# CITY OF ALBUQUERQUE

**RE: Valle Prado Units 1 - Tracts 9 and OS-3 (File: C09D011)**  
**Revised Grading and Drainage Plan, Engineer's Stamp Date 11-4-2014**

<b>CITY OF ALBUQUERQUE</b> <b>PUBLIC WORKS DEPARTMENT</b>	
<b>VALLE PRADO</b> <b>UNIT 1</b> <b>GRADING AND DRAINAGE PLAN</b>			
Design Review Committee	City Engineer Approval	Mo./Day/Yr.	Mo./Day/Yr.
City Project No.	Zone Map No.	Sheet	Of
XXXXXX	C-09-Z	1	2

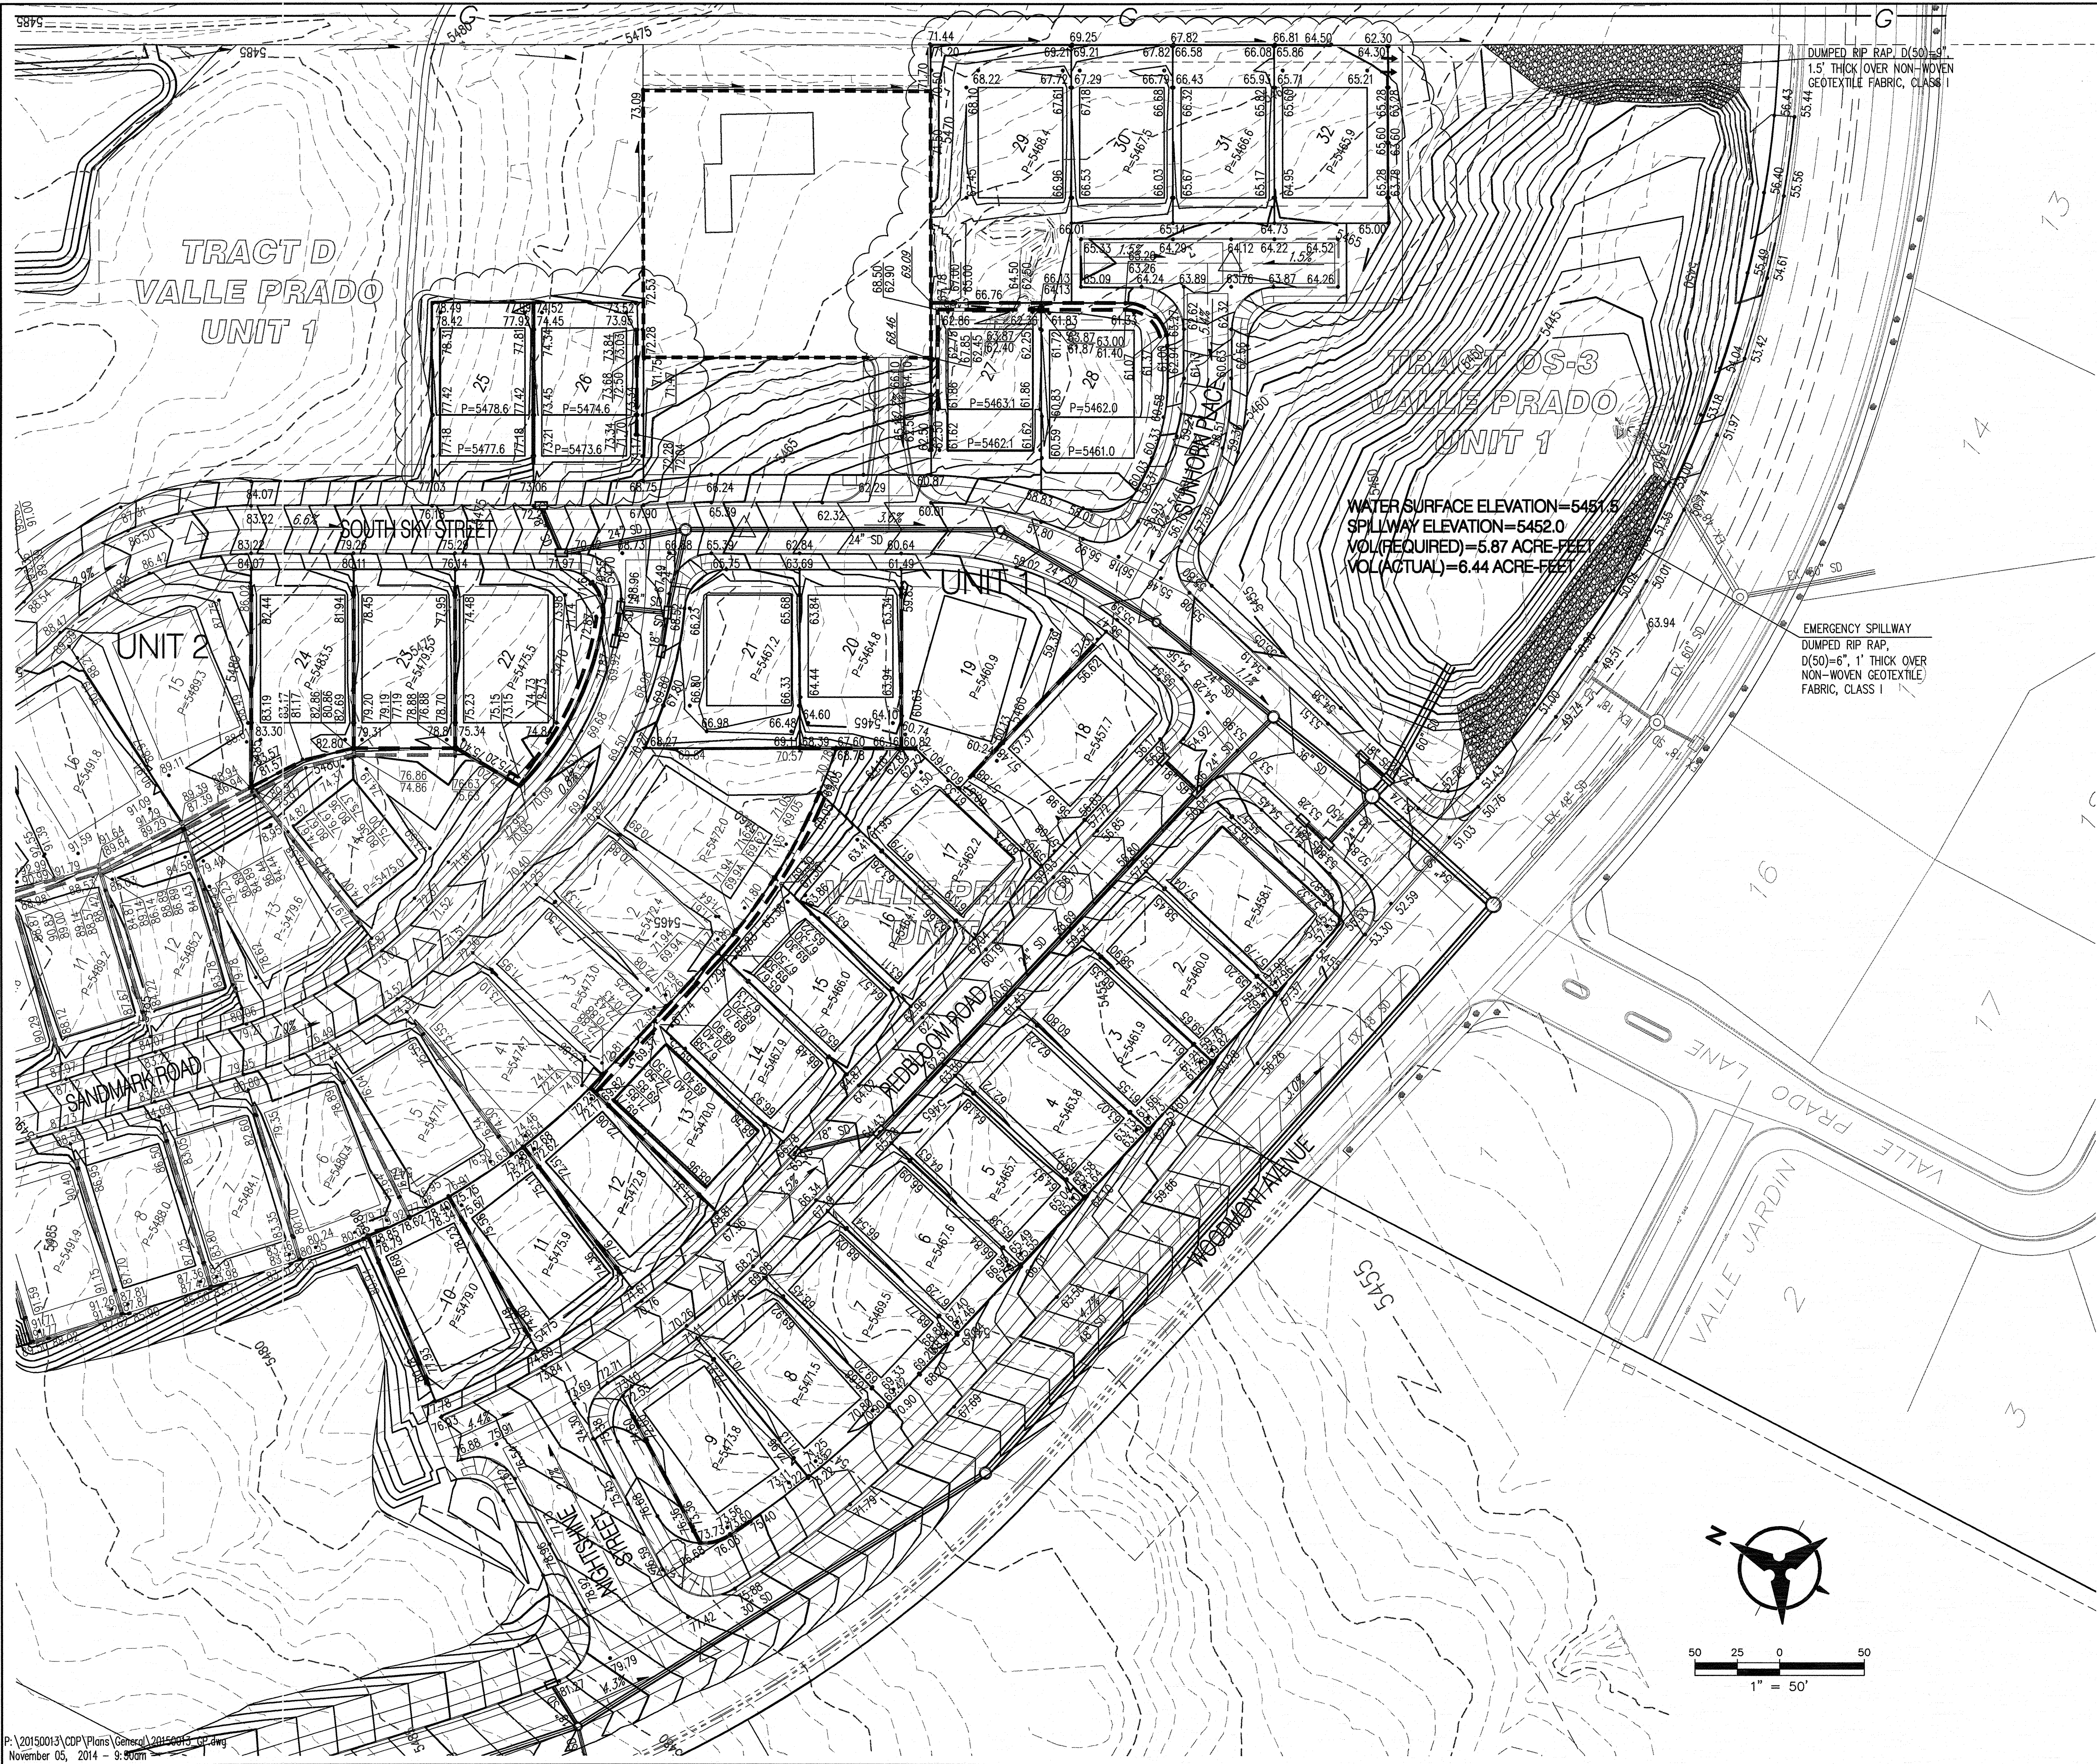
- 1) Remove parallel lines shown between open space Tract D and lot 25. They appear to be errors.
- 2) The wall between lots 25 and 26 needs to be delineated as a retaining wall

It is noted that the major changes from the previously approved plan are changes in retaining wall locations adjacent to the well house, and the removal of retaining walls adjacent to Pond E by lowering grade. The lower grade calls for mountable curb in front of Lot 32. If you have any questions, you can contact me at 924-3695.
